# BOARD OF ZONING APPEALS STAFF REPORT

**Agenda Item:** BZA Docket No. 22-006

**Application Type:** **Developmental Standards Variances**

**Summary:** Paul Kats on behalf of Munster Church, Inc. requesting multiple variances from the Civic Zone Building and Lot Standards; Private Lighting Standards; Vehicular Parking, Bicycle Parking, Loading Space & Trash Receptacles; and Streetscape Repairs, Replacements, & Improvements sections to permit the construction of an addition to the Munster Church and the construction of a new multipurpose accessory building on the same site at 214 Ridge Road.

Figure 4 Building facade position shown in red; Ridge Road Frontage line shown in blue

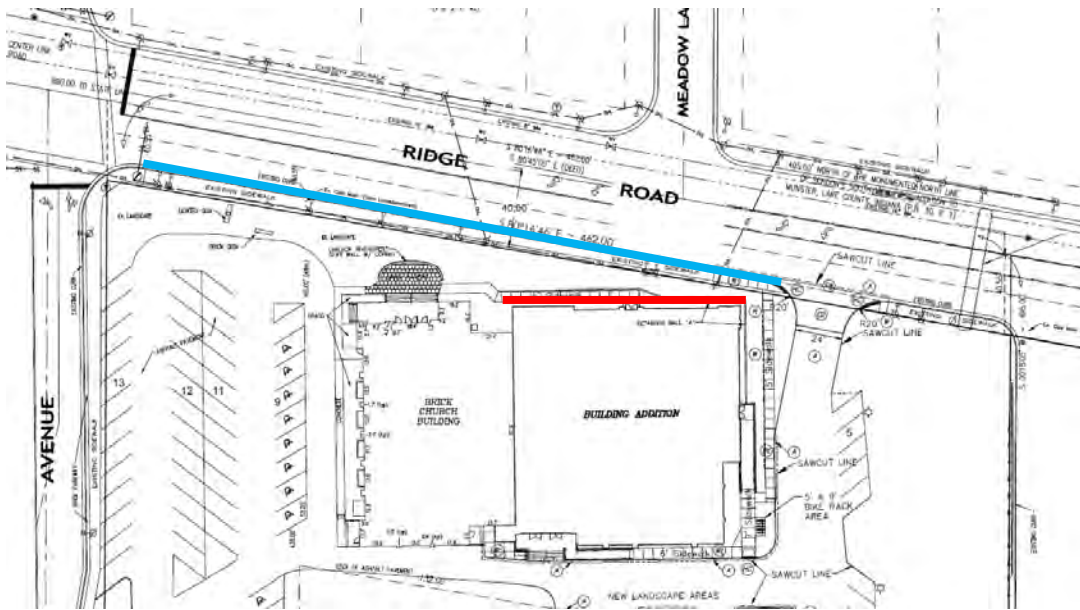
1. TABLE 26-6.405.B CIVIC ZONE STANDARDS Façade Position – required to be parallel to straight Frontage Line or to tangent of curved Frontage Line.

**Required:** The proposed building addition must be positioned parallel to Ridge Road

**Proposed:** The proposed building addition is positioned on a straight east-west line.

Figure 7 Portions of parking lot not meeting minimum illumination standard

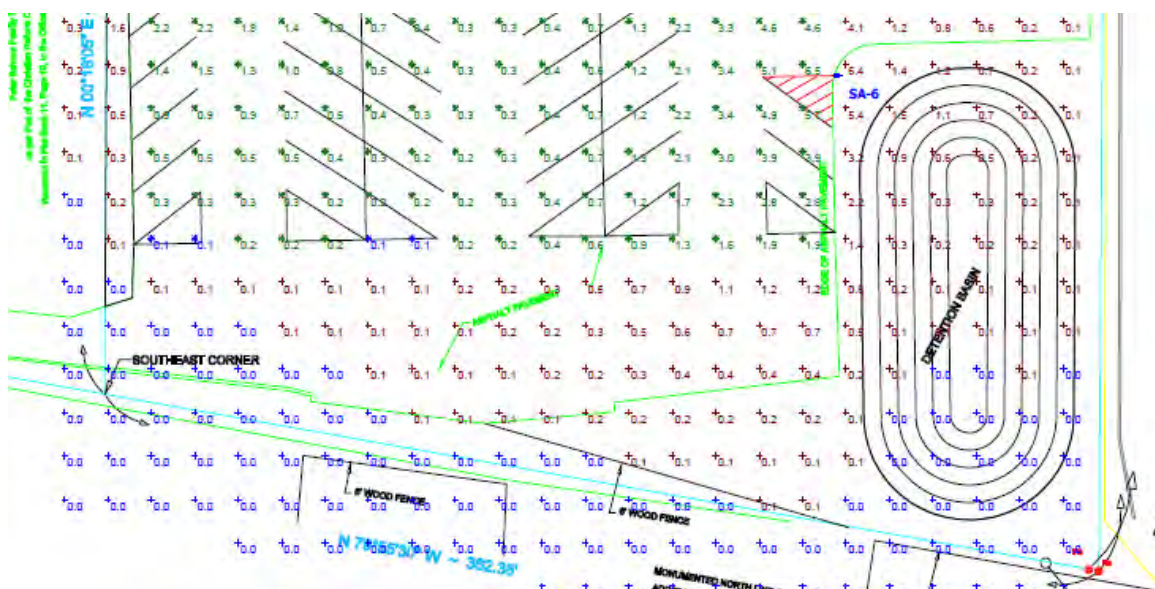
**Required:** Described above.

**Proposed:** Areas along the south edge of the east parking lot are illuminated at a level less than 0.4 foot-candles.

Figure 9 Location of new landscape islands.

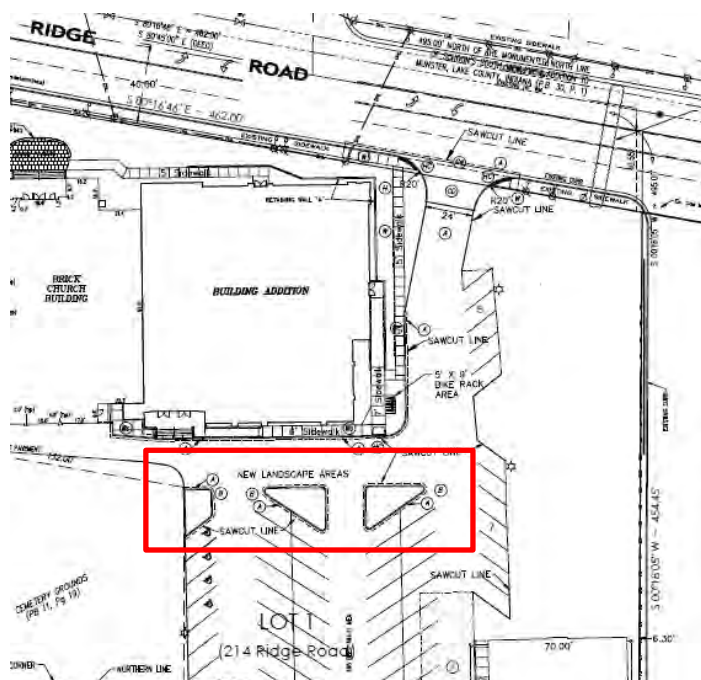
**Required:** Landscape islands are required to be installed in existing parking lots when a new building is constructed, but the requirement can be waived if they can't be installed without removing required parking spaces. In this case, there are 18 existing areas at the ends of parking rows that can be converted from asphalt to landscape islands.

**Proposed:** Only three new landscape islands are proposed south of the building addition.

SITE PLAN

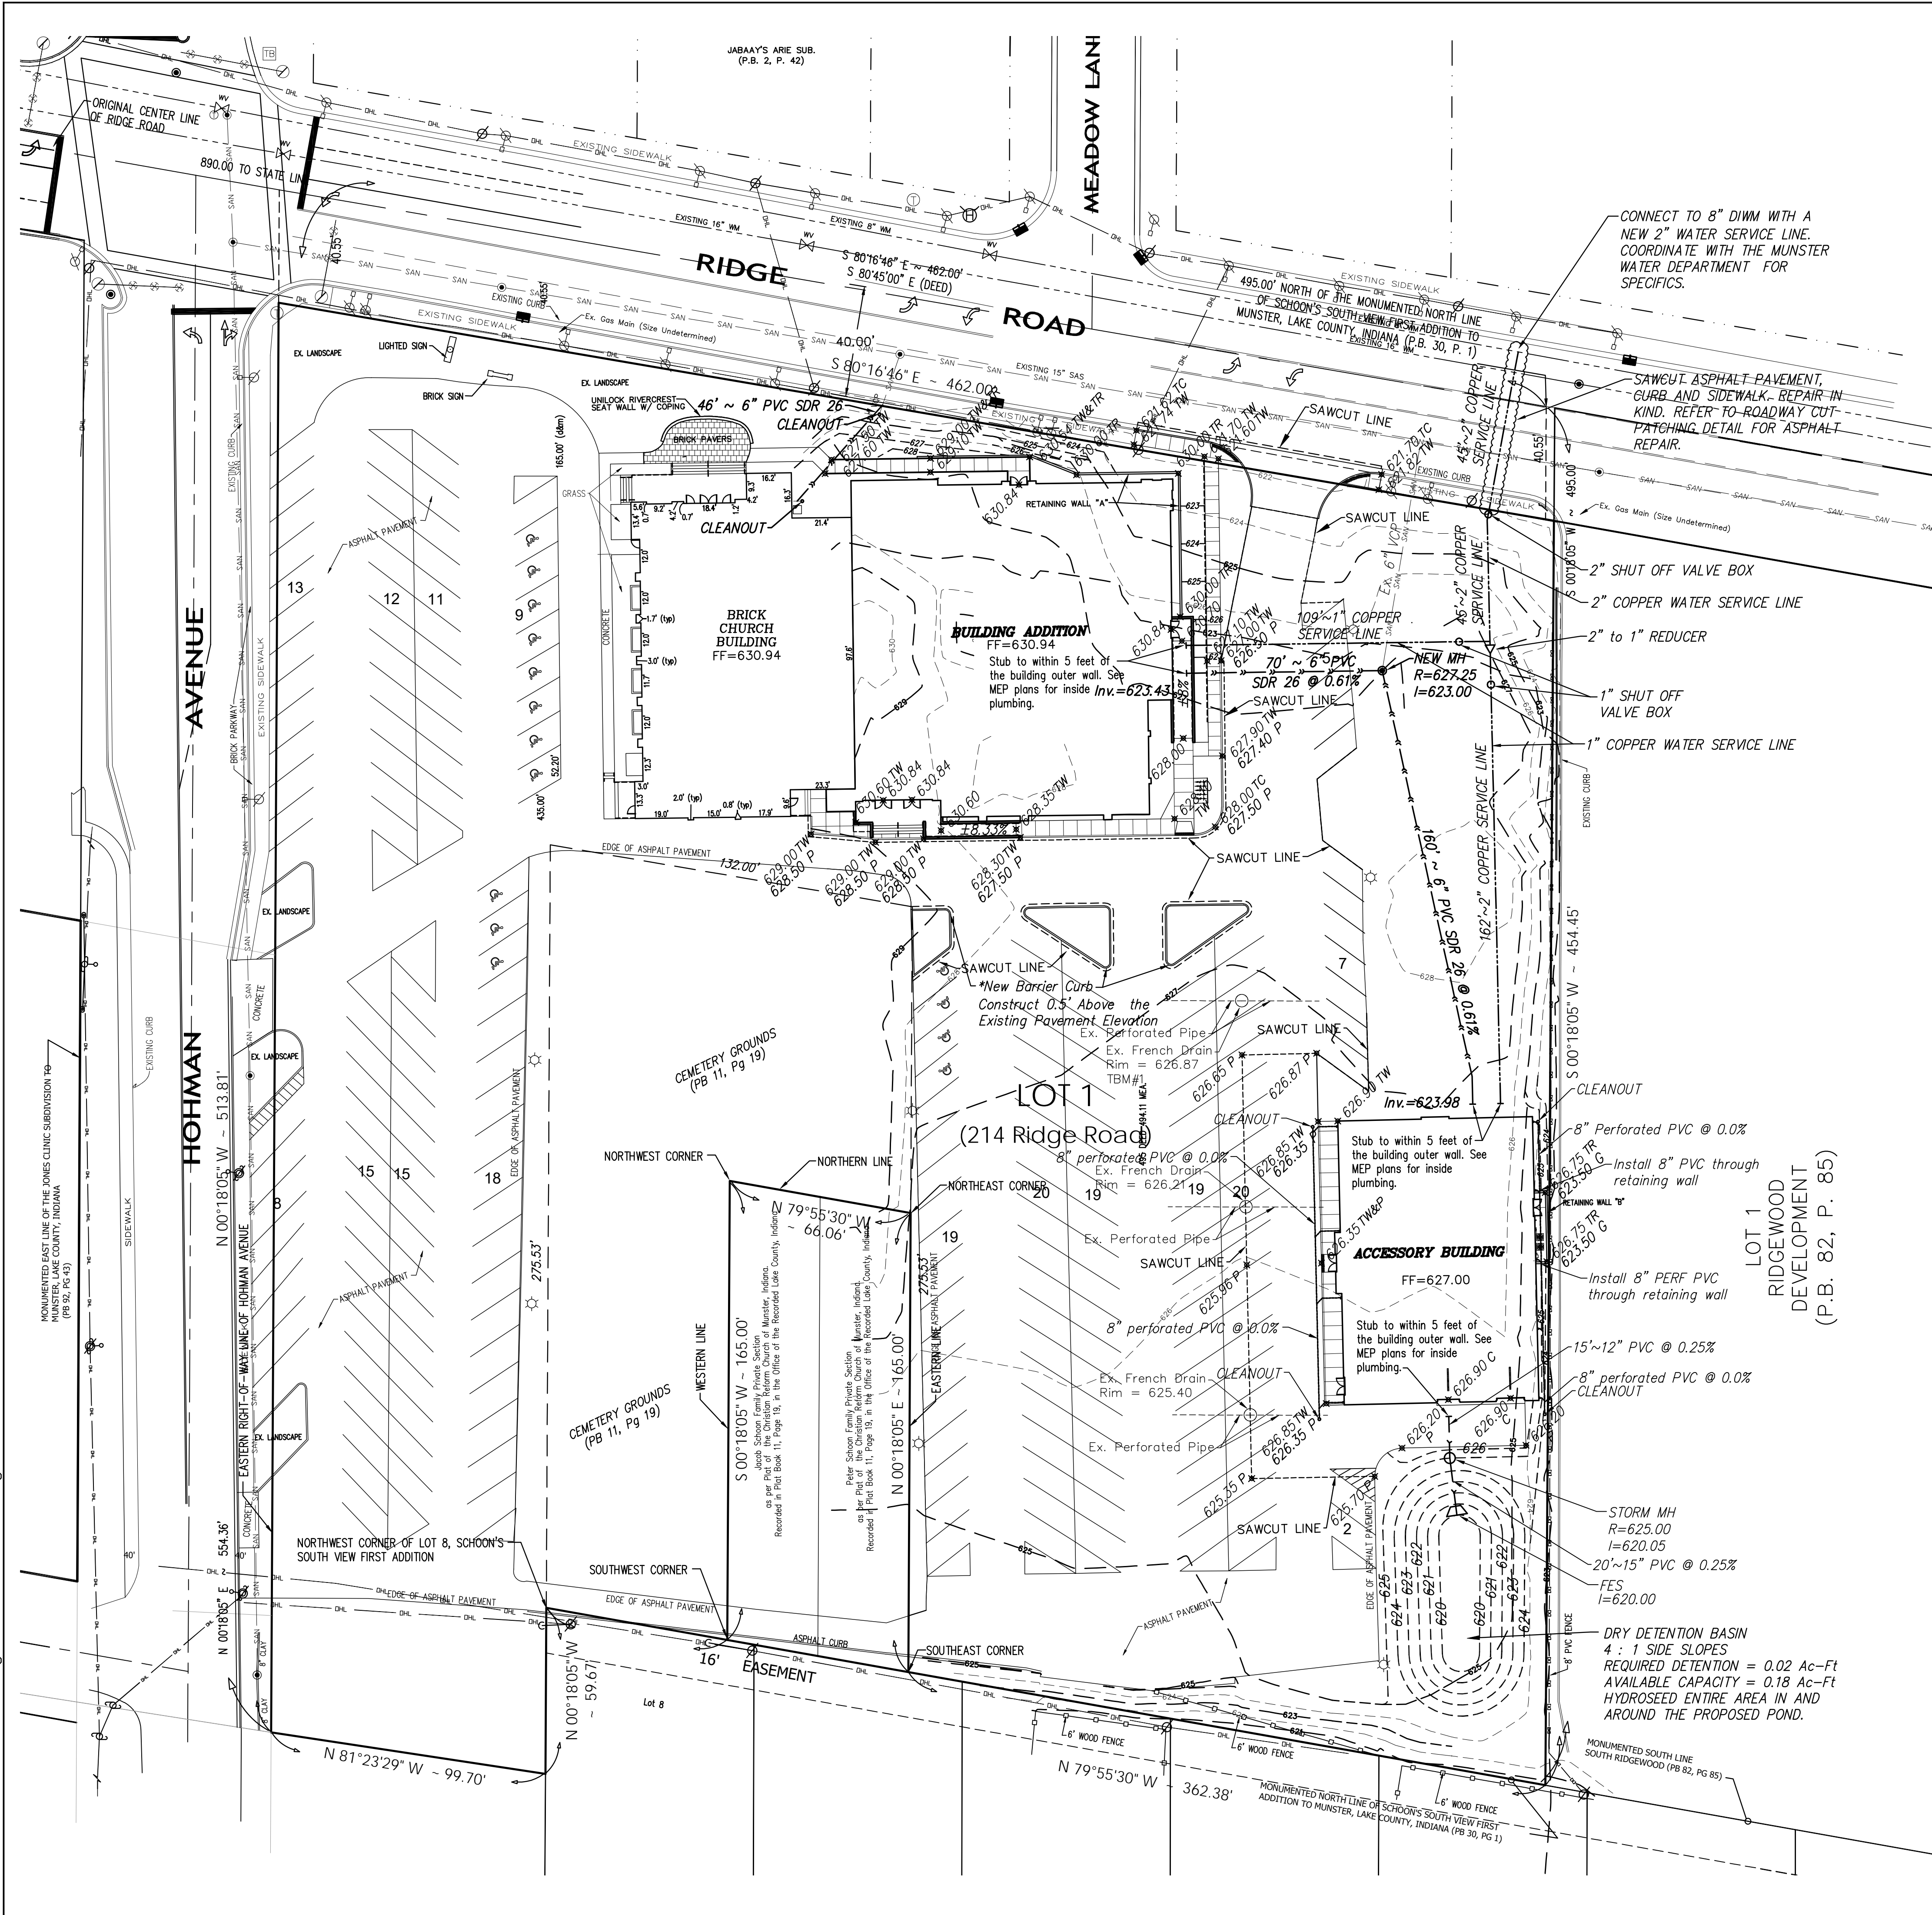
1. TABLE 26-6.405.O-1 VEHICULAR PARKING REQUIREMENTS Place of Worship: 1 per 3 auditorium seats + adequate bus space for activities of institution + passenger loading space. **Number of seats in church not shown on plans. This is needed to determine required parking.**

2. TABLE 26-6.405.O-1 VEHICULAR PARKING REQUIREMENTS Place of Assembly: .3 spaces per capacity determined by Town Fire Chief. **Occupancy of accessory building not shown on plans. This is needed to determine required parking.**

1. My interpretation of the Munster zoning ordinance is that the CIVIC DISTRICT building standards do not apply to the Munster CRC Outbuilding if it is classified as an Accessory Building. The Plan Commission may rule that these standards do apply to accessory buildings, in which case the only applicable standard is the requirement that the roof pitch be 8:12 – 14:12.

*Response: The number of seats in the sanctuary has been added to the Site Plan, Sheet C-2.0, and the required number of spaces has been added as well.*

*Response: The number of seats in the new accessory building has been added to the Site Plan, Sheet C-2.0, and the required number of spaces has been added as well.*

*Response: A 5' x 9' bike rack area has been added near the south east corner of the new building addition at the edge of the sidewalk as can be seen on the Site Plan, Sheet C-2.0.*

*Response: A note has been added to the Site Plan, Sheet C-2.0, that notes that the pitch of the new accessory building's roof is to be 8:12.*
